HIGHWAY WORK PROPOSAL

<u>COUNTY</u>	<u>STATE PROJECT</u>	<u>FEDERAL</u>	<u>PROJECT DESCRIPTION</u>	<u>HIGHWAY</u>
Wood	6320-00-75	N/A	Plainfield - Wisconsin Rapids; STH 173 to STH 54	STH 073

Addendum No. 01
 ID 6320-00-75
 Revised Sheet 29
 March 20, 2024

*Replace entire subsection titled **Stage 3:** under section titled **Construction Staging** with the following:*

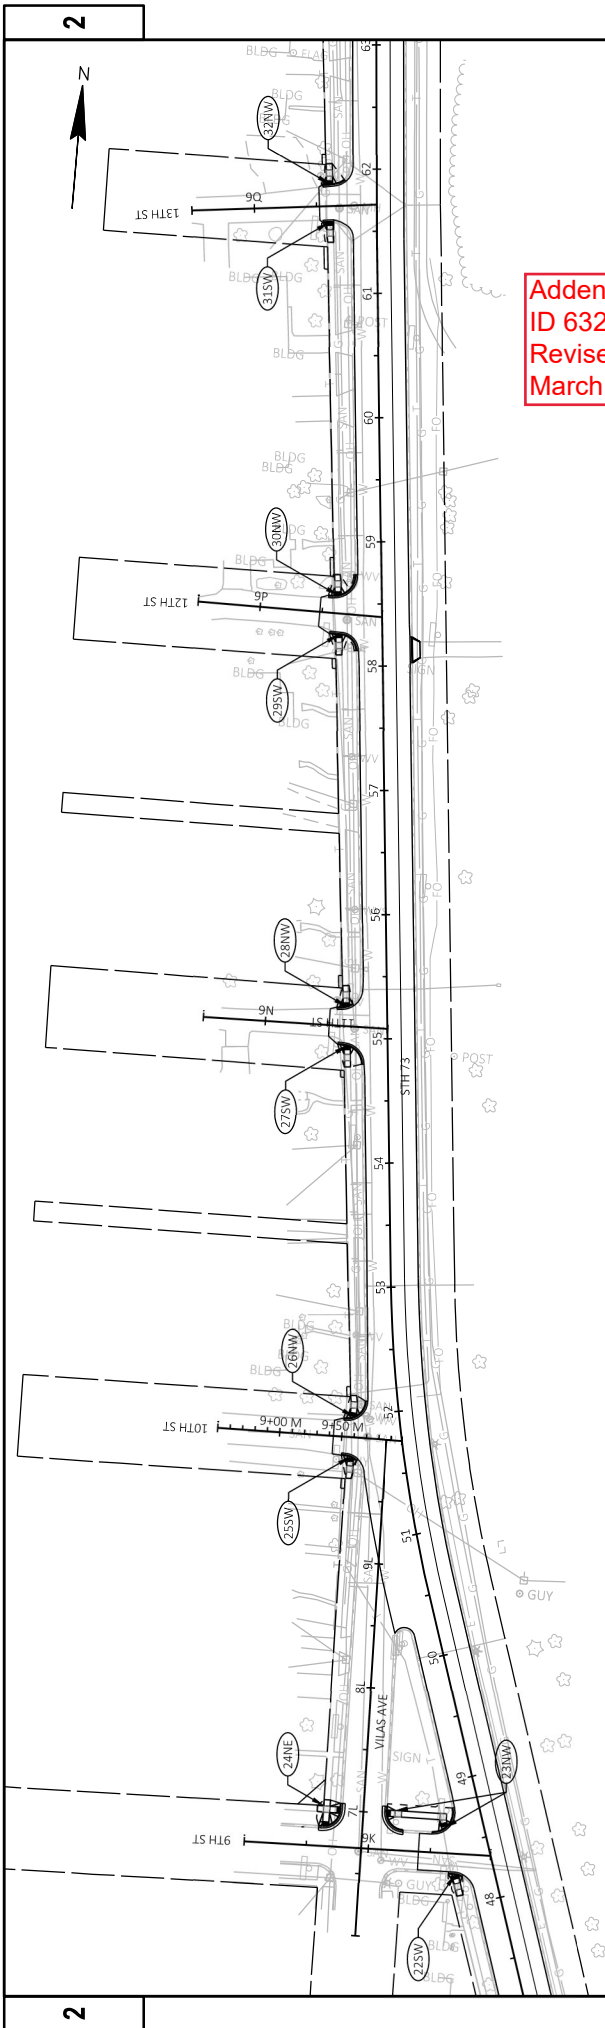
Stage 3: Mill and pave the left northbound lane from the STH 73/STH 173 intersection to the Moccasin Creek Bridge. From the Moccasin Bridge to the end of the project, pave the northbound lane. Remove the widening on STH 73 from Station 100+50 to Station 113+00. Construct the curb ramp near Station 109+00 RT. No impacts shall occur within Riverside Park.
